# Q-332R1

## SVE BULLETIN

QVM BULLETIN: Q-332R1 DATE: 10FEB2021

### 2021MY F-150 PICKUP BOX GEOMETRY CHANGES (vs 2020MY F-150)

**SECTION COMPARISON ALONG THE PICKUP BED SIDE:**

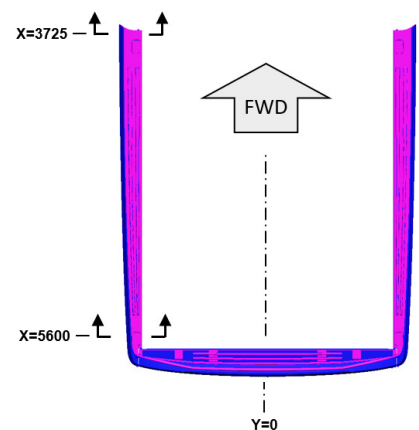
Some notable geometry changes to the new 2021MY F-150 pickup box upper moldings and cargo width (wheelhouse) were made, which may affect the fit of canopy tops, camper shells, toolbox, etc. that are mounted on the pickup box.

Below are some representative CAD sections of 2020MY F-150 overlaid onto 2021MY F-150. CAD data of the upper moldings and related sheet metal panels can be obtained via the BBAS website ([www.fordbbas.com/contactus](http://www.fordbbas.com/contactus)).

MY2020: Magenta  
MY2021: Blue

**SECTION COMPARISON ALONG THE TAILGATE:**

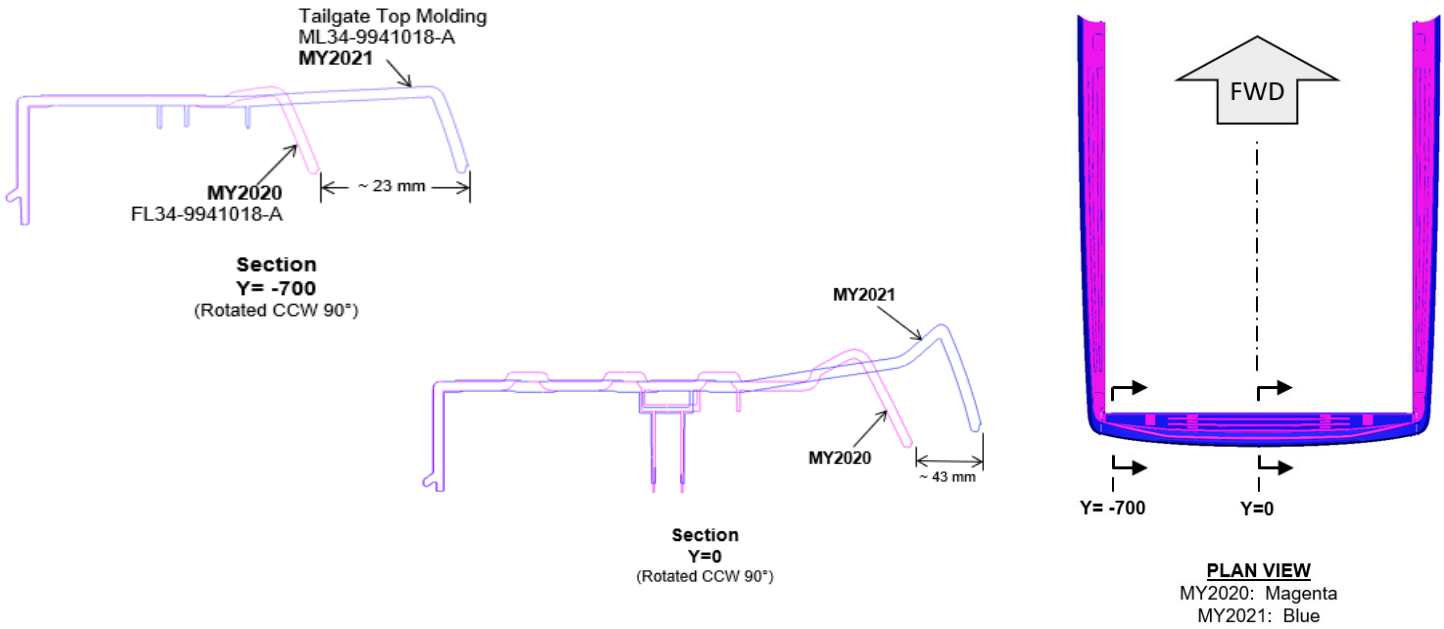
REVISION	UPDATE	REVISION DATE
Q-332R1	REVISED DIMENSIONS IN SECTION COMPARISON AT TAILGATE AND UPDATED THE PICKUP BOX DIMENSIONS eSOURCE BOOK	10FEB2021
Q-332	INITIAL RELEASE	05FEB2021

**2021MY F-150 PICKUP BOX DIMENSIONS eSOURCE BOOK REFERENCE**

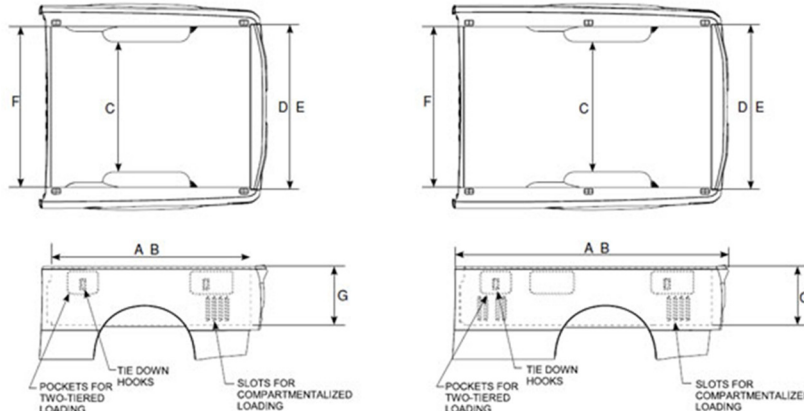
The dimensions in the GREEN circle are the correct Cargo Width @ Wheelhouse.
